Title: Advisory Committee on Reactor Safeguards
ABWR Subcommittee Meeting

Location: Rockville, Maryland

Date: Thursday, April 21, 2011

Lower drywell flooders fusible plug valve (FPV) failure modes.

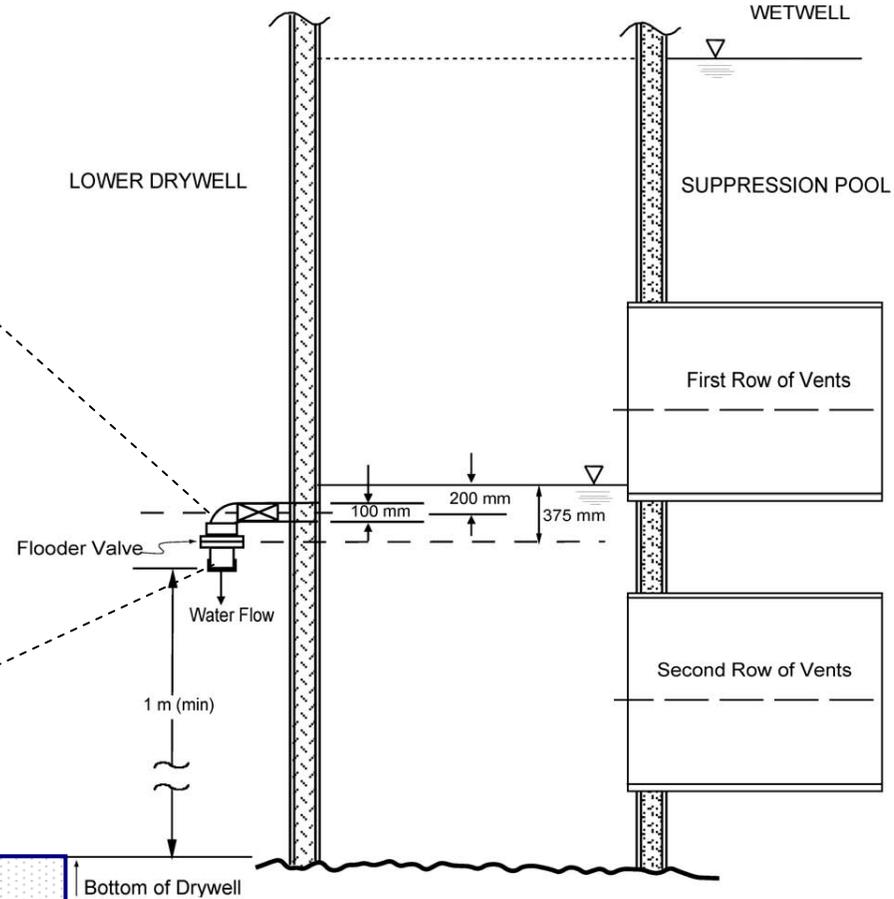
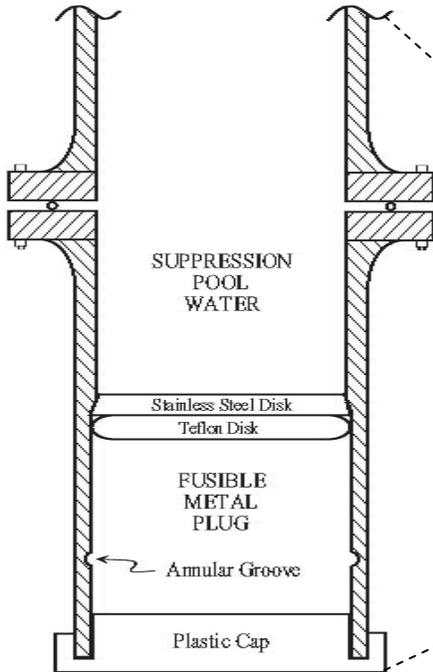
Additional question asked on valve leakage during normal operation:

Response: On October 20, 2010, the results of a failure modes and effects analysis performed by Toshiba on the lower drywell flooders (LDF) fusible plug valves (FPV) was discussed.

- FMEA functional requirement for the FPV is zero leakage under all operating and design basis accident conditions.
